HILLSIDE INVESTMENTS OFFICE BUILDING JSP 17-84

Consideration at the request of Hillside Investments for Preliminary Site Plan and Storm Water Management plan approval. The subject property contains 1.7 acres and is located in Section 12, on the southwest corner of Haggerty Road and Thirteen Mile Road. The vacant parcel is zoned I-1, Light Industrial. The applicant is proposing to construct a two-story professional office building with a total of 25,881 square feet.

PLANNING REVIEW

Preliminary Site Plan Landscape Review

SHEET
Landscape Plan

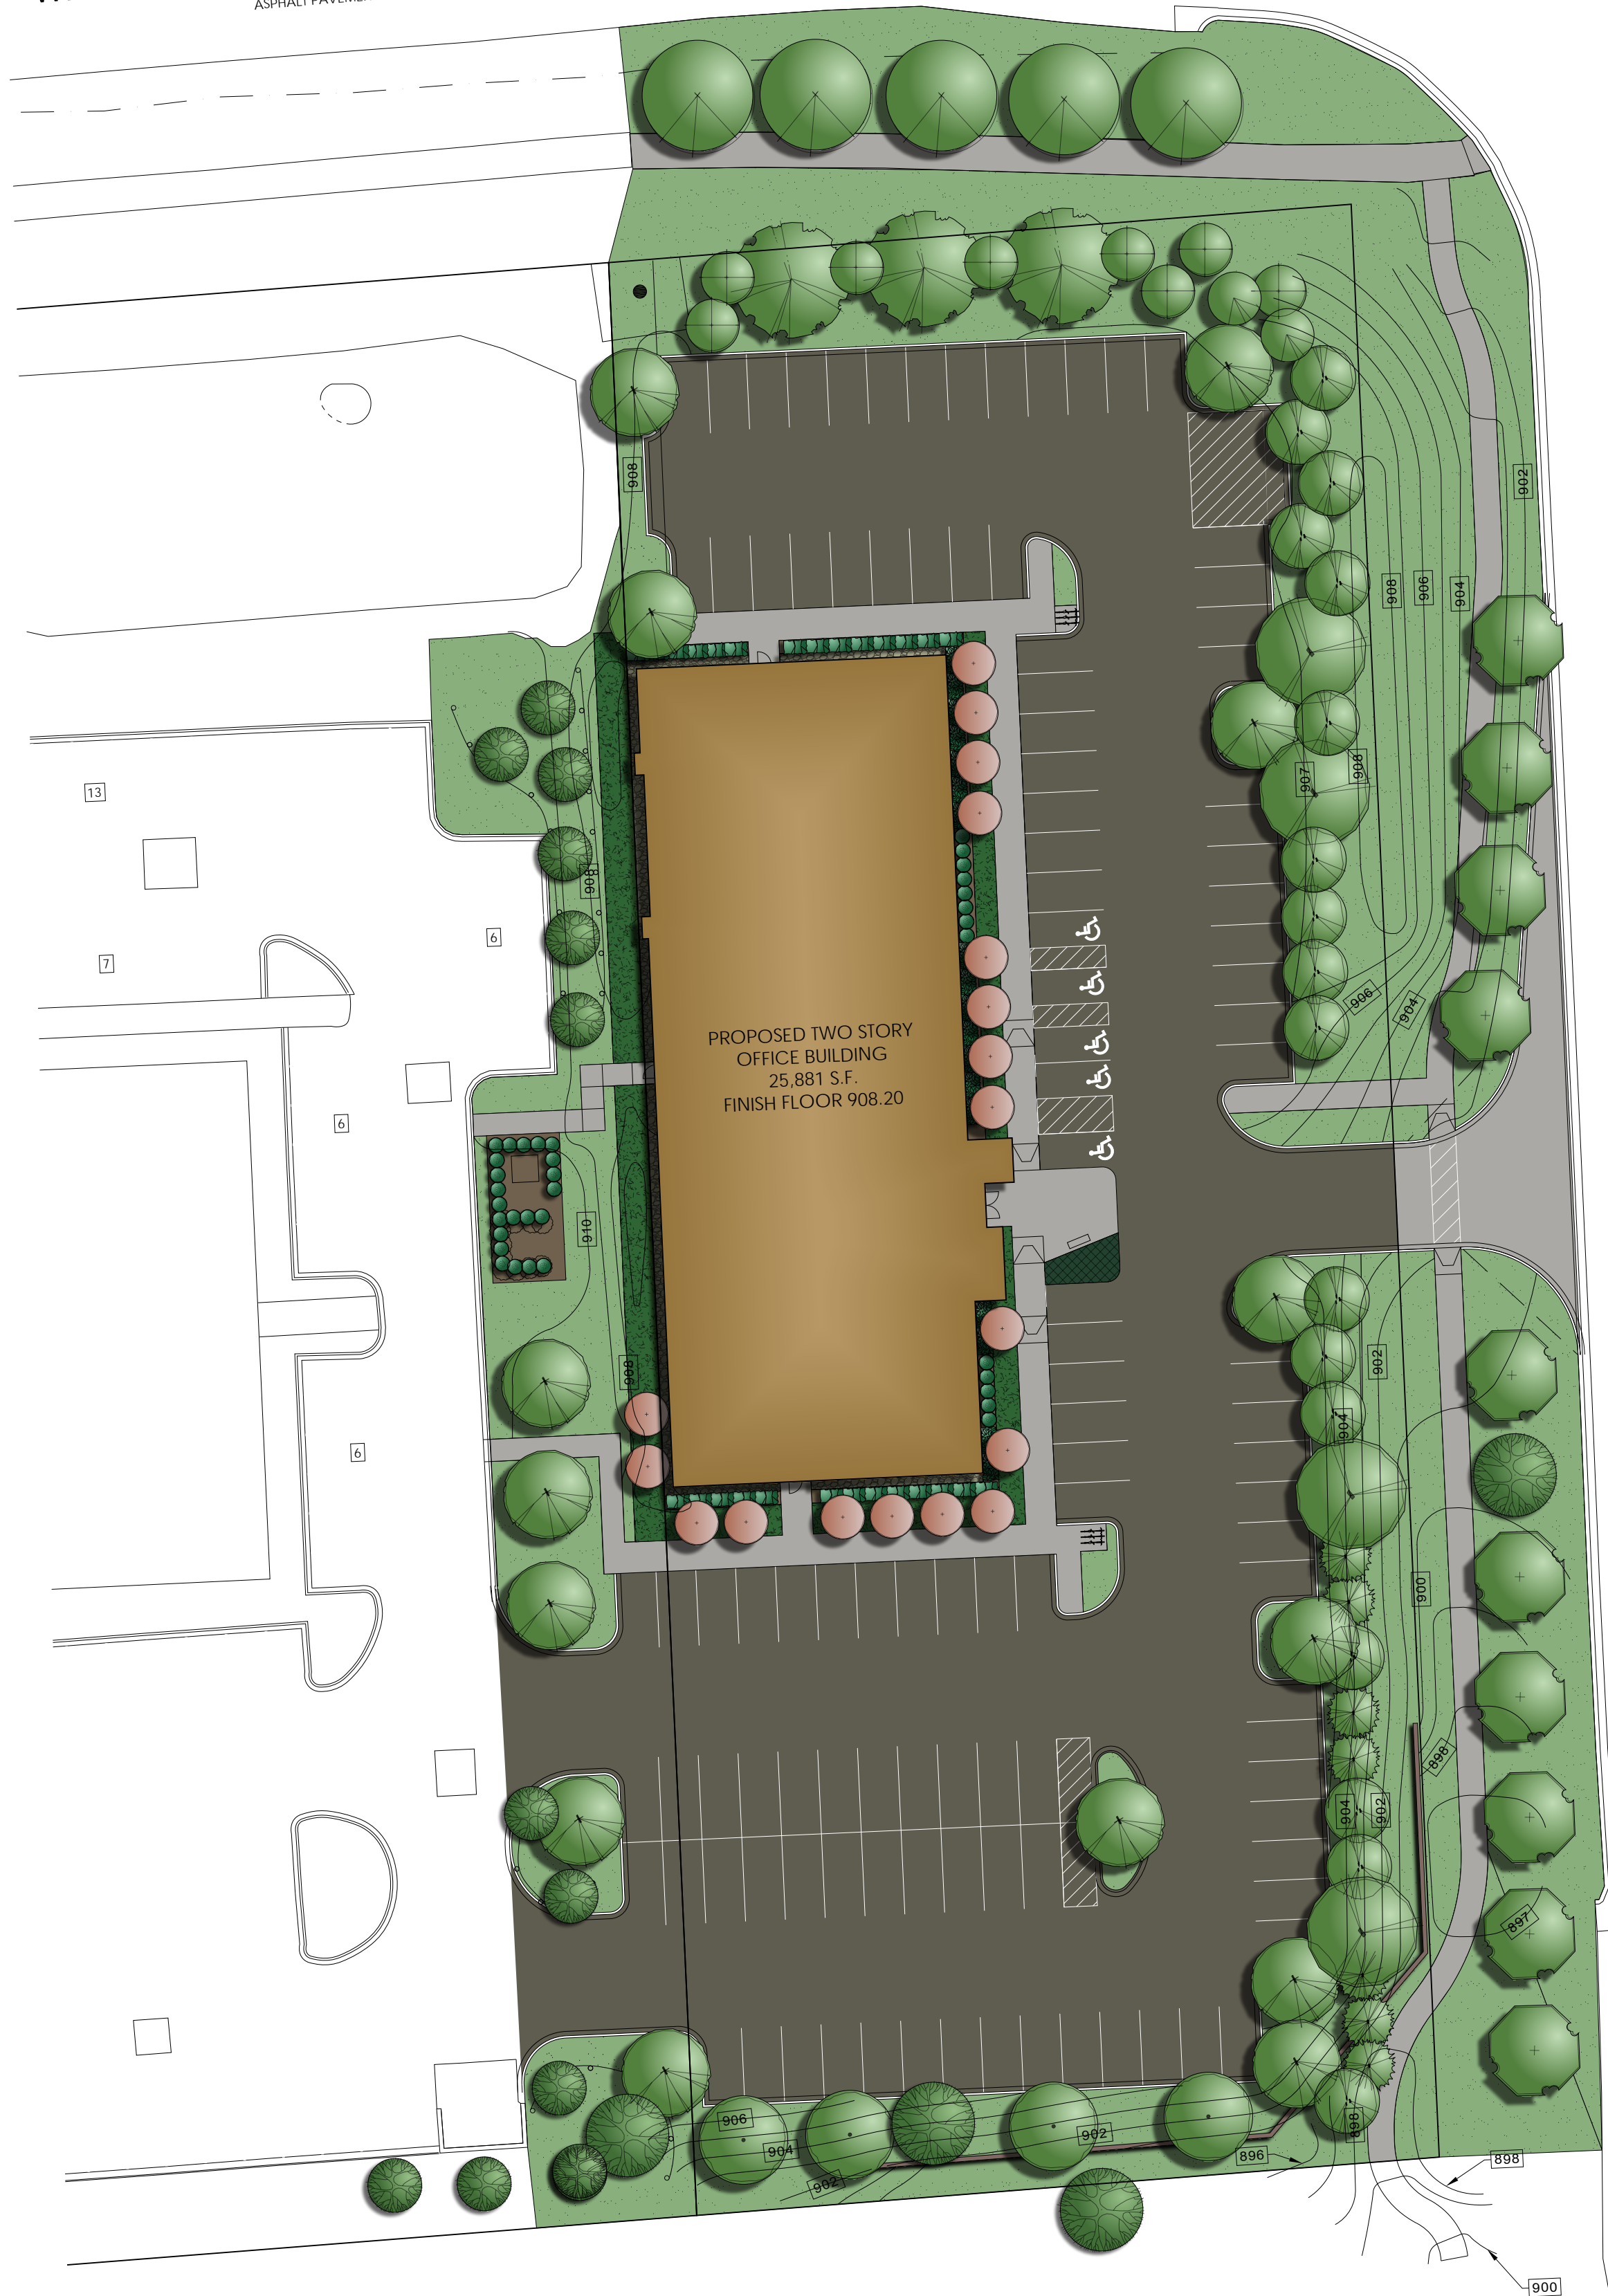
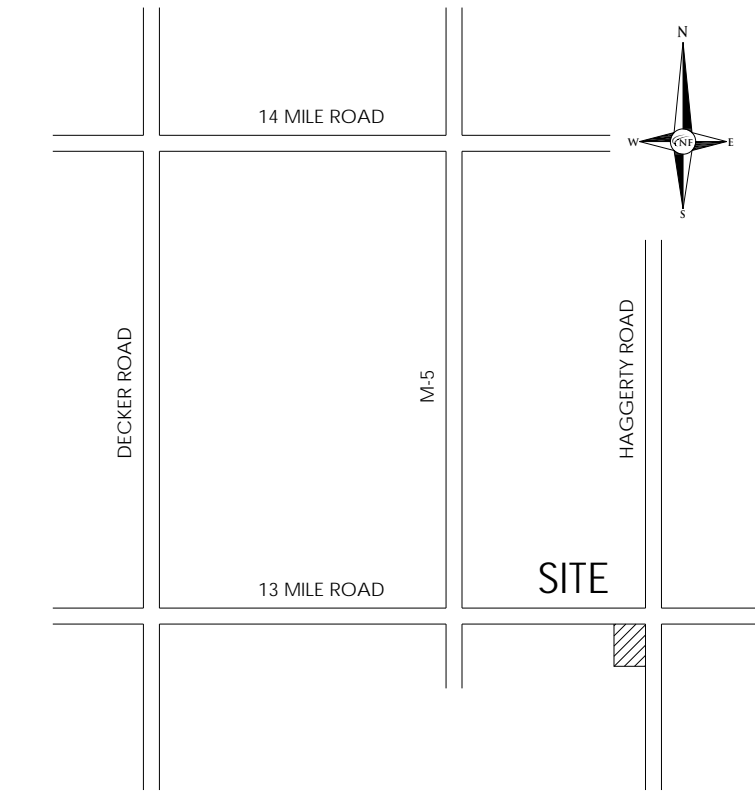
1. The required numbers of large and subcanopy trees are provided.
2. **The required 3 foot tall berm is not provided. If it is not added, a landscape waiver will be required. Please list this and any other waivers requested in a table on the landscape plan, listing the waiver, the impact (what is missing) and the justification for the waiver.**

1. The required numbers of large and subcanopy trees are provided.
2. **The required 3 foot tall berm is not provided due to the site grading. If it is not added, a landscape waiver will be required. Please list this and any other waivers requested in a table on the landscape plan, listing the waiver, the impact (what is missing) and the justification for the waiver. Based on the site grading, this waiver request will probably be supported by staff.**

1. Parking lot interior landscaping calculations were revised to show the correct requirement and correct number of trees provided.
2. **Parking lot trees are required in the islands at the northeast and southeast corners of the building in order to break up the bays along the north, east and south sides of the building. The islands also need to be expanded to have at least 200sf of landscape area.**

1. Perimeter calculations have been provided, but the basis was understated. The outer perimeter of the north, east and south sides of the parking lot, less the access ways is actually 686 lf, not 127.
2. **Please revise the calculations and provide the required deciduous canopy trees.**
3. **The revised regulations allows for greenbelt canopy trees within 15 feet of the curb to also count as perimeter trees. If trees are double-counted, they should be labeled as both for verification of the count.**

Please show areas for snow deposits on the landscape plan.

Response: Haggerty Road Berm -The topography of the site is such that the proposed parking lot is as much as 9' higher than the proposed sidewalk elevation along Haggerty road near the south end of the property. Even deploying a partial retaining wall as shown on Sheet C-4, the resulting grade is at the maximum of a reasonably maintainable slope. Further, that slope and the Haggerty ROW is utilized for a variety of proposed trees as shown on Sheet L-2. The applicant feels this topographic condition together with the significant amount of landscaping provided justifies a waiver of the berm requirement along the Haggerty road edge of the parking lot and respectfully request same. The applicant further agrees to the comments relative to the minor landscape revisions required to be shown on the final submission sets.
